Cobb County Community Development Agency
Zoning Division
1150 Powder Springs St. Marietta, Georgia 30064

Case # Z- 20
Public Hearing Dates:
PC: 04-03-18
BOC: 04-17-18

TERRELL MILLS PARK - APARTMENTS
 LAND LOTS 782 & 783
 OF THE 17 DISTRICT 2 SECTION
 OF THE 17 DISTRICT 2 SECTION
 OF THE 17 DISTRICT 2 SECTION

Z1 ZONING SITE PLAN
 SHEET 1 of 1
 DATE: 01/07/2018
 DRAWN BY: [Name]
 CHECKED BY: [Name]
 SCALE: 1"=50'

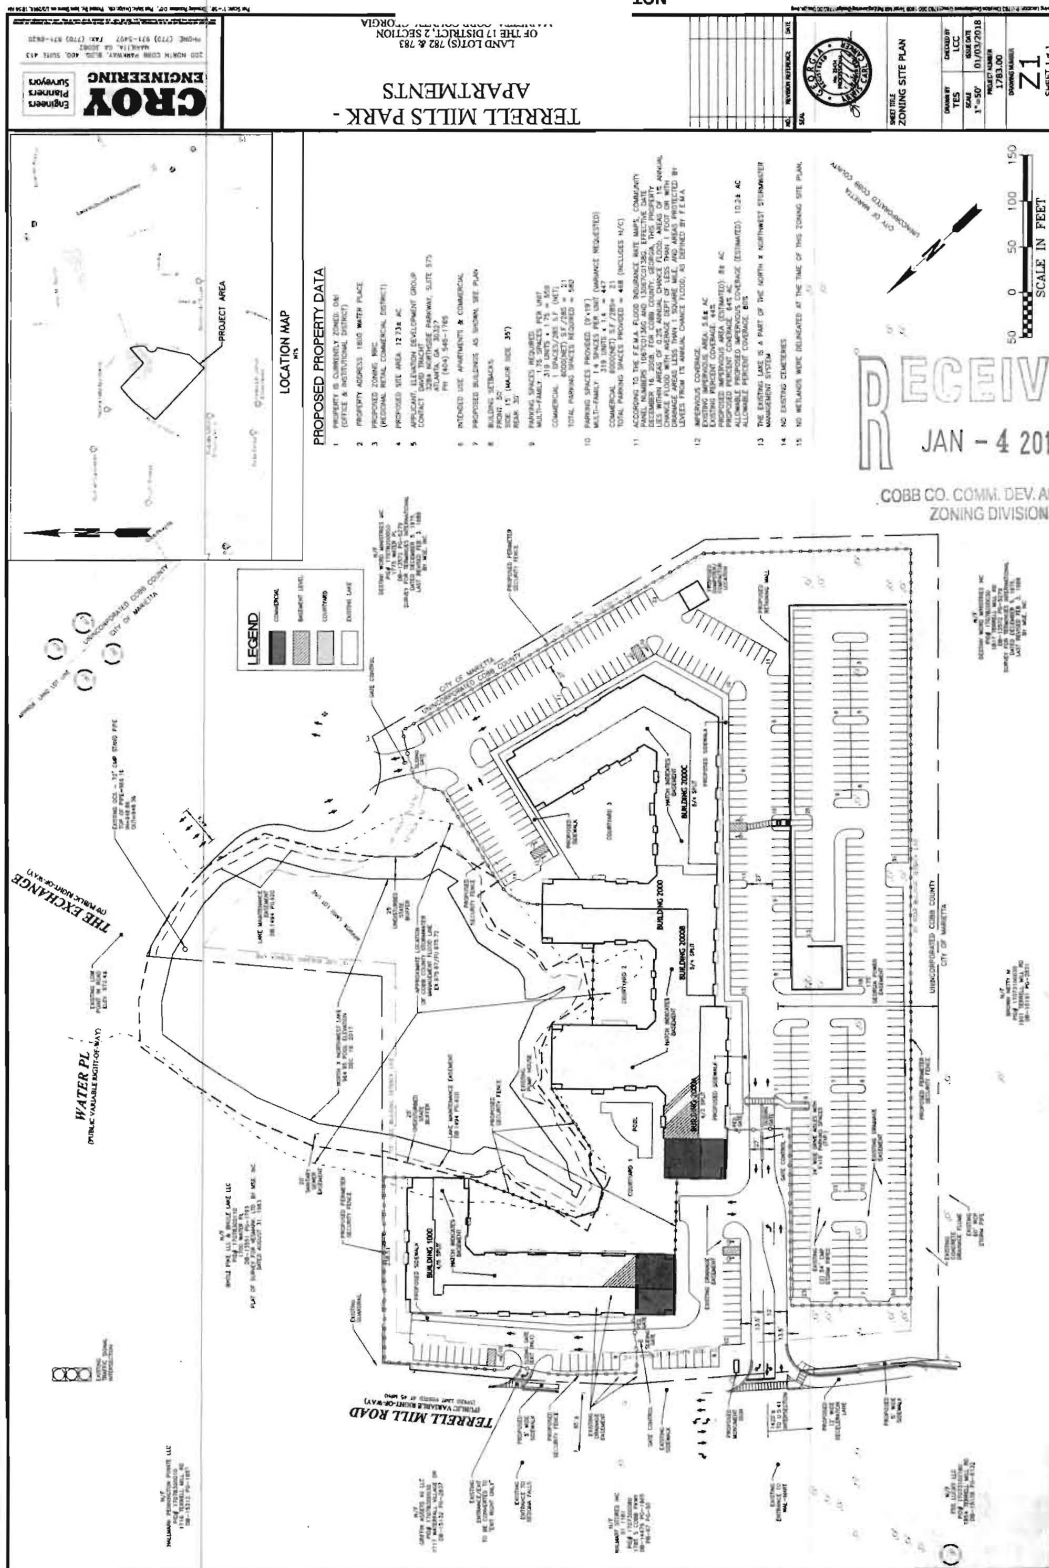
Yes. This application will require a contemporaneous variance to waive the number of required parking spaces from 579 to 468.

Modifications will be required to incorporate the Cobb County Fire Marshal's Office comments.

ACCESS: Fire apparatus access roads shall extend to within 150 feet of all portions of the facility or any portion of the exterior wall of the first floor (State Modifications IFC 503.1 2006 Edition).

All access roads shall meet the American Association of State and Highway Transportation Officials (AASHTO) design manual live load standard HS20 (75,000 lbs.) with an unobstructed width of not less than 20 feet, 25 foot inside radius, 50 foot outside turning radius and unobstructed vertical clearance of not less than 13 feet 6 inches.

Dead-end access roads in excess of 150 feet shall be provided with a turn-around (IFC 503.2.5 2006 Edition). Cul-de-sac with or without an island: minimum 60-foot radius to outside curb, measured to inside of curb and a minimum lane width = 24 feet (Cobb County Development Standard 401.09). Single-Family cul-de-sac without island: 38-foot outside radius with island reverts to commercial dimensions. Hammerhead turn-around: total of 110 feet needed (45 feet + 20 feet wide roadway + 45 feet).

Aerial apparatus access shall be required for all structures over 30 feet in height measured from the lowest level of fire department access to the ceiling height of the highest occupied floor level. Aerial fire apparatus access roads shall be a minimum width of 24 feet maximum of 40 feet from the structure and be positioned parallel to one entire side of the building. No overhead utility and power lines shall be located within the aerial fire apparatus access. (Cobb County Development Standards 401.08.02.1)

GUEST PARKING: The Fire Department does not support the reduction of parking. It is the recommendation of the Fire Department that parking be supplied on a per bedroom basis.

6. Streambank buffer zone: Yes
7. County Buffer Ordinance: 25'
8. Stormwater discharges must be controlled not to exceed the capacity of the existing downstream storm drainage system.

9. Project engineer must evaluate the impact of increased volume of runoff generated by the proposed project on existing lake and downstream drainage system.

10. Structural fill must be placed under the direction of a qualified registered geotechnical engineer (PE).
11. Water Quality/Quantity contributions of the existing lake/pond on site must be continued as baseline conditions for proposed project. Additional underground stormwater management must be provided such that there is no increase in offsite peak discharges from existing conditions.

12. Grading adjacent to existing lake must not result in any loss of flood storage volume.
